SERVICE BULLETIN

SERVICE BULLETIN NO: 53-009 REF NO: 108

FUSELAGE ENGINE MOUNTING-FRAME ATTACHMENT-FITTINGS - INSPECTION

Engine Mount Attachment Fittings - Inspection/Repair Figure 1

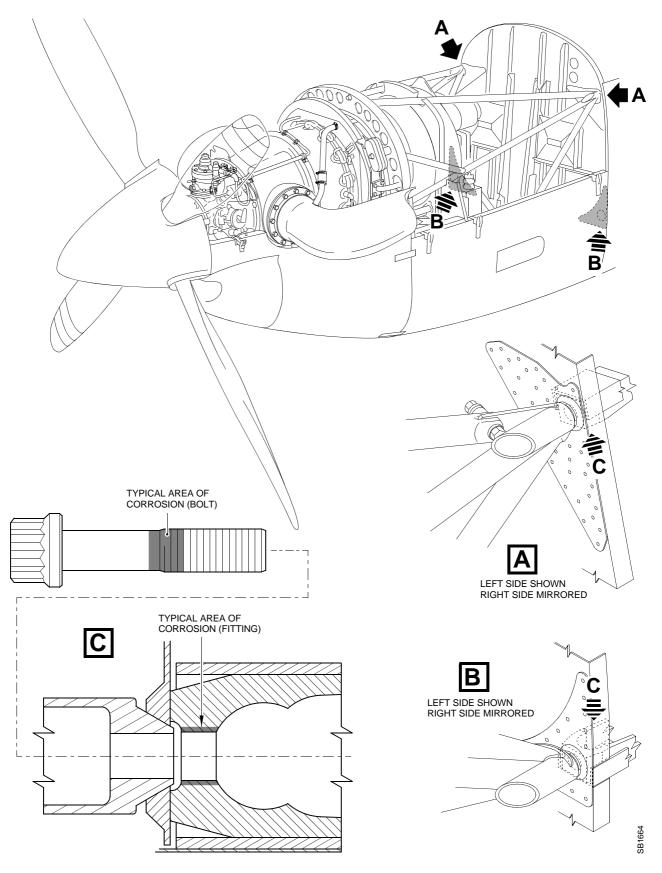
A. Inspection/Repair (Ref. Fig 1)

- (1) Remove the bolt and washer from one of the four engine mounting-frame attachment points (Ref. AMM 71-20-01, Page Block 401).
- (2) Do a visual inspection for corrosion on the removed bolt.
- (3) Do a visual inspection for corrosion in the bore of the attachment fitting. Do this with a boroscope. If you find corrosion, do the subsequent steps:

- (a) Use aluminum wool (Material No. P02-002) to remove surface corrosion.
- (b) If you cannot remove all of the corrosion contact Pilatus for repair information.

- (c) Clean the bore and the threads of the barrel nut with solvent (Material No. P01-008) and absorbent paper (Material No. P02-031).
- (d) Remove all swarf and debris from the attachment fitting. If necessary, you must remove the barrel nut and/or the engine mounting frame to do this. Make sure there is no swarf and debris in the joints between:

- · The attachment fitting and the barrel nut
 - The attachment fitting and the engine mounting frame.
- (e) Apply a layer of CCC solution (Material No. P07-001) to the bore.

- (f) If necessary, install the barrel nut and/or the engine mounting frame.
- (4) Install the new bolt (P/N 571.20.09.031) and the washer (P/N 938.75.11.105) (Ref. AMM 71-20-01, Page Block 401).
